Staff Report

Re: PLNPCM2020-00378 The Abbie

Planned Development

PROPERTY ADDRESS: 1739 S. Main Street
PARCEL ID: 16-18-301-009-0000
MASTER PLAN: Central Community Master Plan
ZONING DISTRICT: CC Corridor Commercial

TITLE:
SITE PLAN

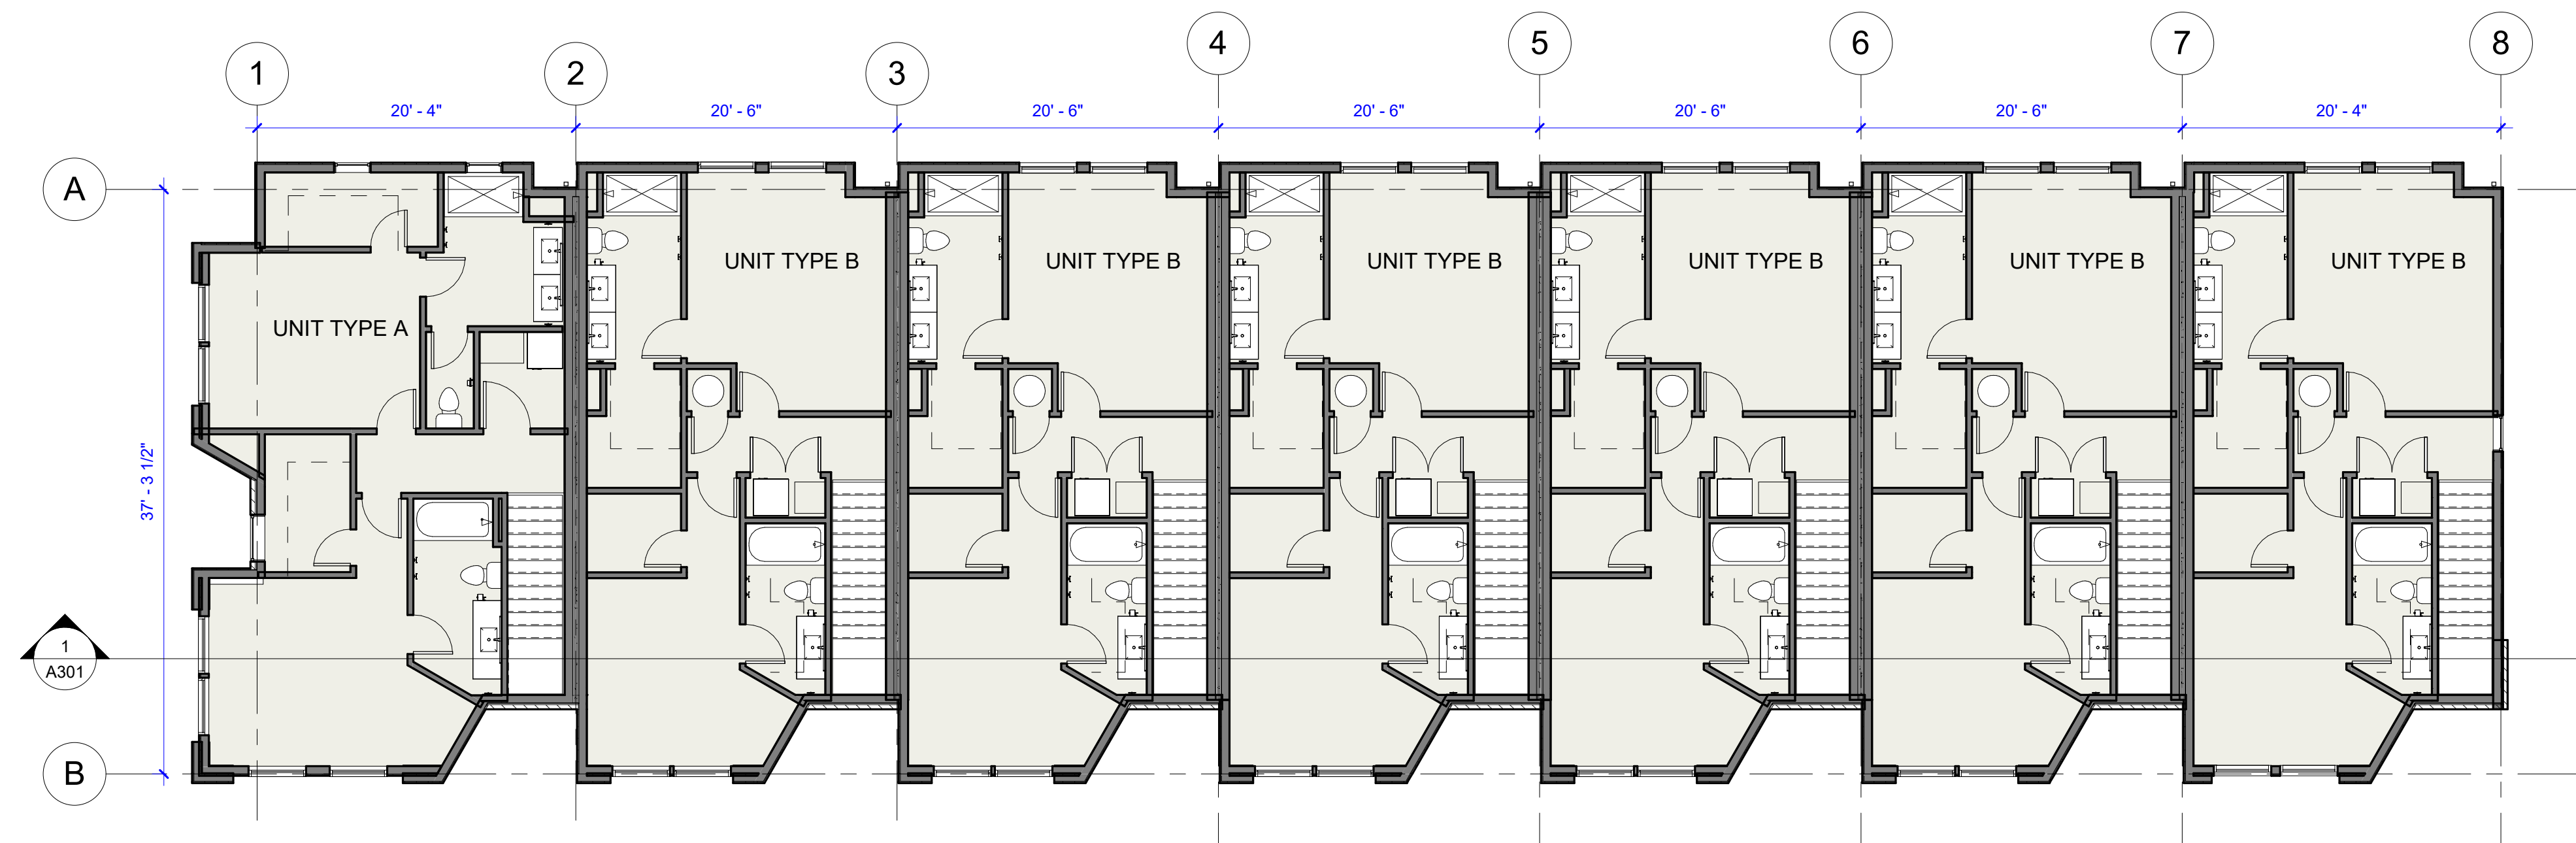
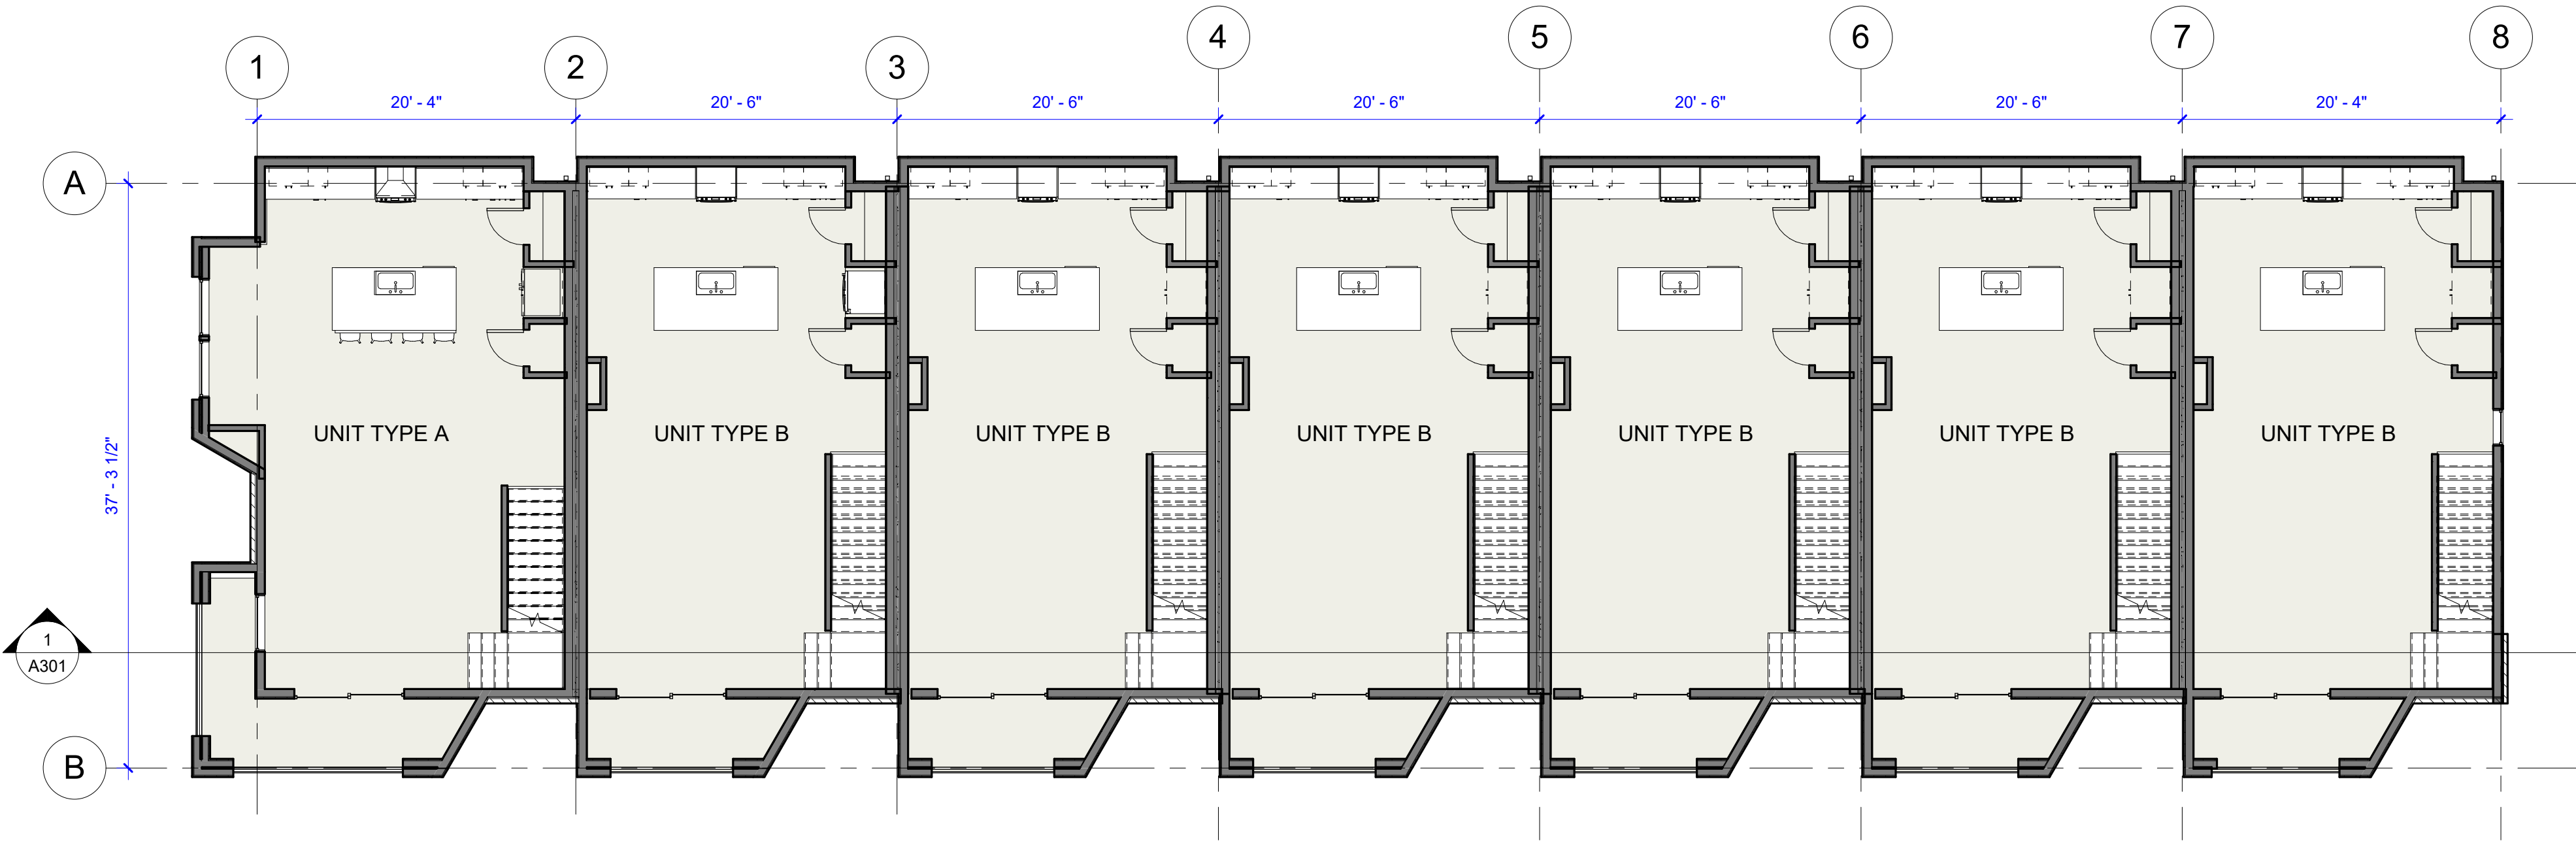
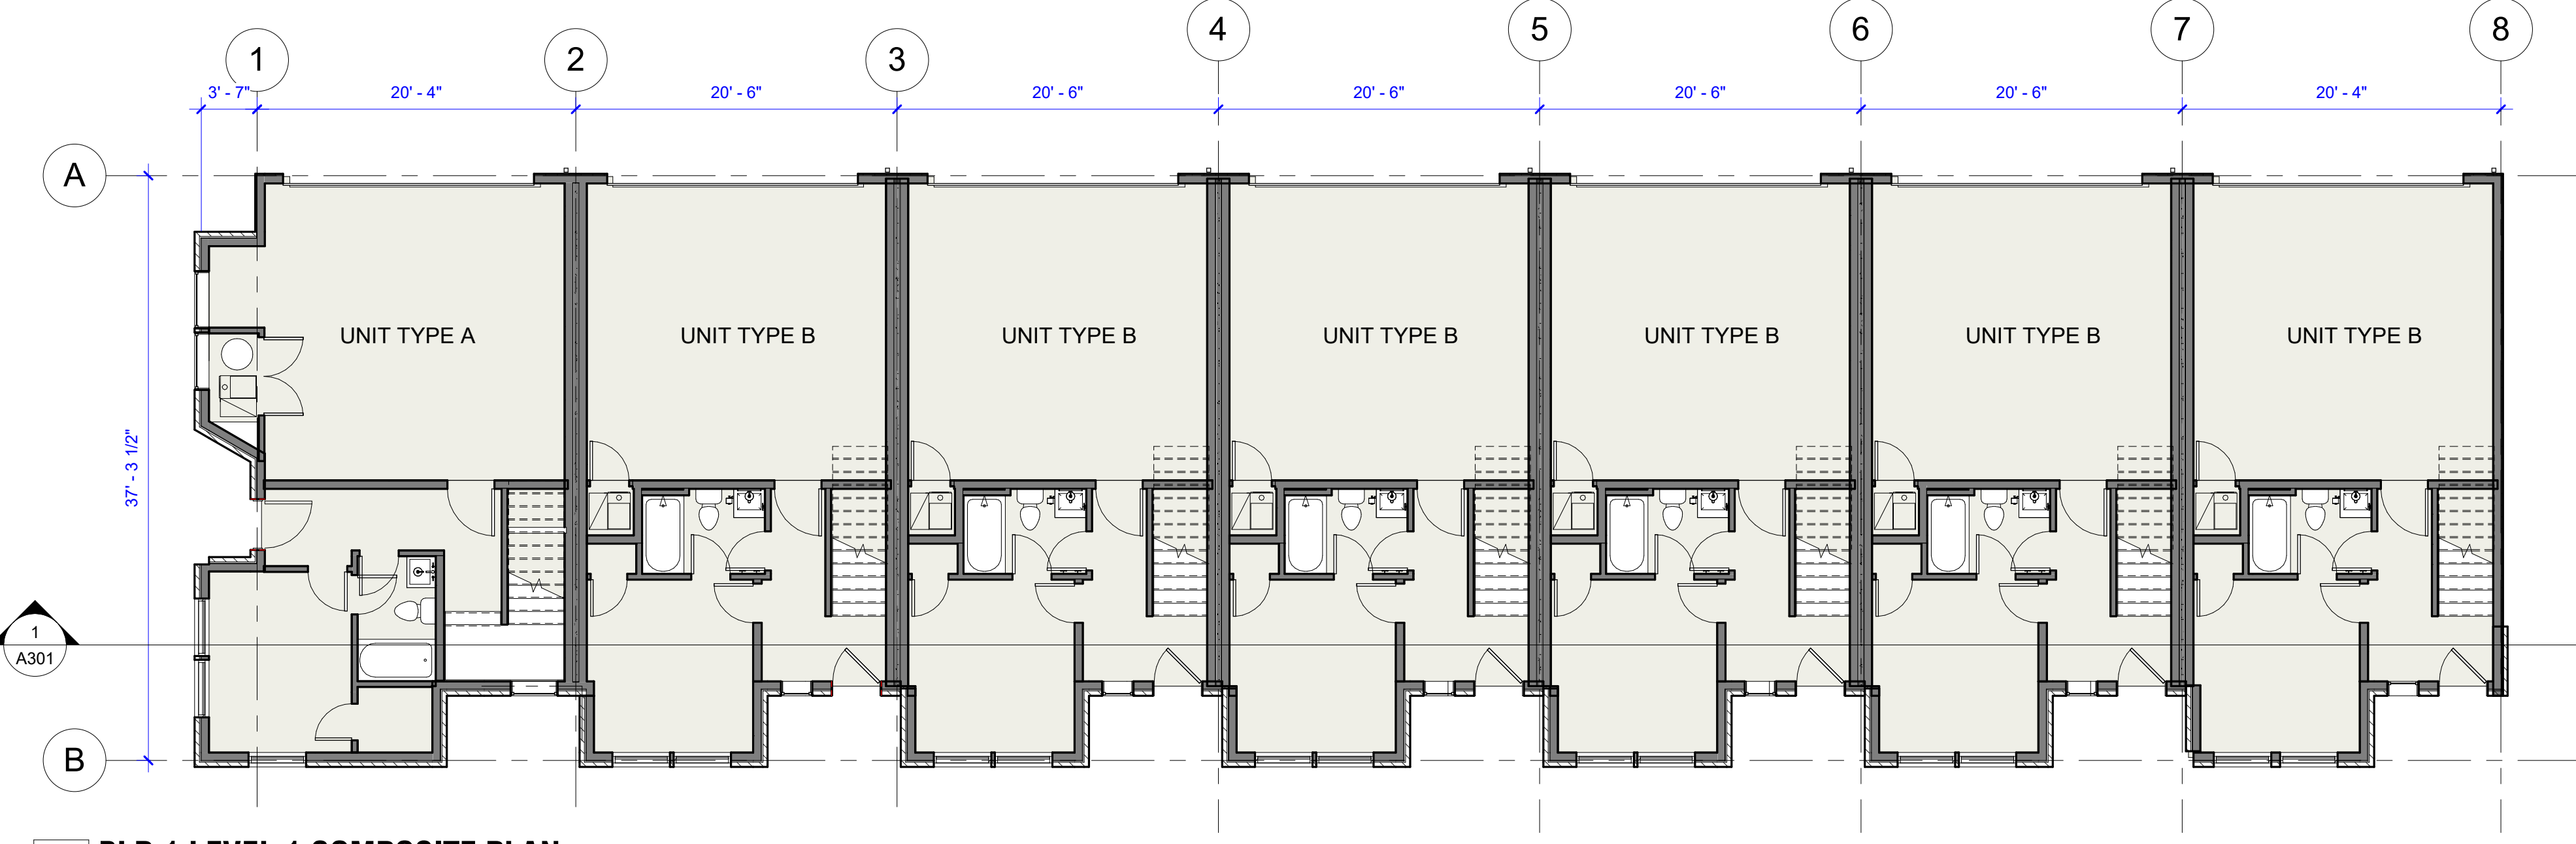
There is a 9.8 foot rear yard setback shown on the site plan submitted on 7/28/20, but not previous plans. A 10-foot setback is required. The front yard setback has an additional 2+ feet than required, I recommend moving building slightly to the west.
